VILLAGE OF WELLSVILLE

## AEROBIC DIGESTER CONVERSION PROJECT

### ADDENDUM NO. 1

JULY 8, 2010

### DRIP EDGE DETAIL

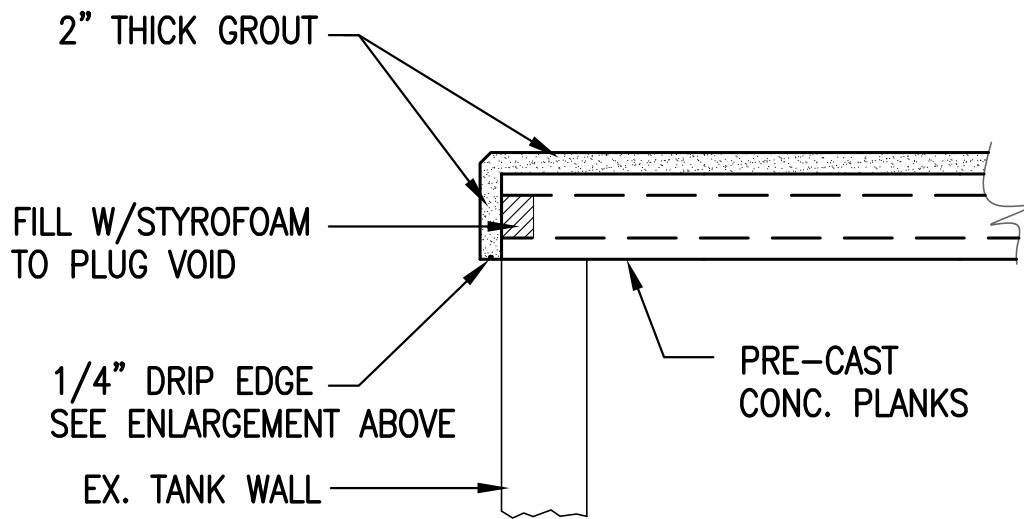
**ADD** Drip Edge Detail Sheet, Aerobic Digester Pre-Cast Concrete Plank Topping
